CAIRNGORMS NATIONAL PARK AUTHORITY

Title: REPORT ON CALLED-IN PLANNING

DEVELOPMENT PROPOSED: OUTLINE PLANNING PERMISSION FOR

REFERENCE: 06/304/CP & 06/305/CP

Fig. 6. Indicative Site Layout and Elevation for Terrace of 4 Houses

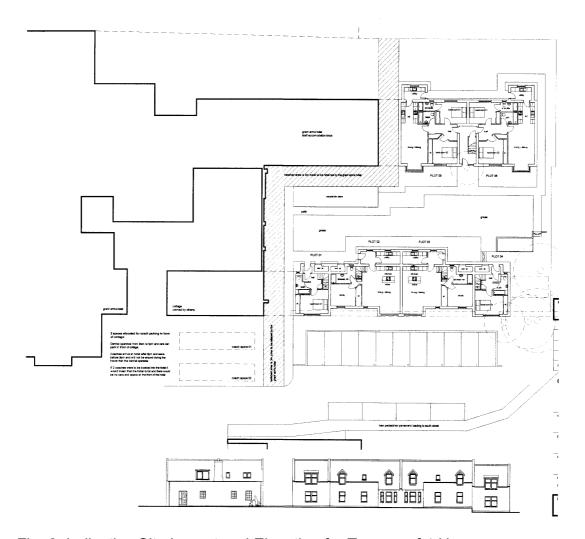
- 34. Concerns have been raised in terms of the amount of development proposed for the site, from various consultees, including Highland Councils Planning and Roads Services. In my view, the existence of the large hotel extension wing to the rear of the hotel and adjacent to the site, provides an imposing, overbearing, and inappropriate scale and design of development for this Conservation Area site, within the grounds of a Listed Building, and in relation to surrounding properties. While limited views from the Square are achievable, it can be seen from other areas. The proposed flatted block is indicated as lower than this extension, but I do not feel it is appropriate to accentuate this overbearing scale or form of development in the location proposed. The flatted block remains of a significant scale and height (12m), in

relation to its neighbours to the north and east. It will be positioned, at its least 6.8m, and at its most 8.8m, from the north boundary where the adjacent building is a one and a half storey residential unit ("Salmornish") with rear garden. The indicative north elevation shows windows serving habitable accommodation which will overlook this boundary. On its east side, the two and three guarter storey gable of the flatted block will sit less than 3m from the mutual boundary with the 2 storey residential properties on this side ("Strathspey Lodges"). These properties are also at a lower level to the proposed site. It is also the case that the hotel extension has windows on its east gable which will be 3m from the blank west gable of the proposed flatted block. Since the proposed building lies in such close proximity to its site boundaries and its adjacent properties, my view is that this block, being of the size and scale indicated, would have an unacceptably high overbearing and impact on the area and the Conservation Area in general.

- 35. The indicative terraced block of 4 houses, aligning with the existing cottage, does represent, in my view, and in the view of the consultees, a more appropriate scale and form of development for this site, in terms of design. However, the amount, quality and potential use of the space between this block and the flatted block is considered to be less than satisfactory. While proposed as a communal grassed area, being limited in depth and configuration, and being "sandwiched between the two blocks and overlooked by the windows on the south elevation of the hotel extension, it does not provide an area where any degree of privacy, ownership or functionality as a useful open space area, can be achieved (policy guidelines do set out requirements for private space provision, in particular for houses). Indeed, users of the communal area would be very close to windows of both the flats and the houses.
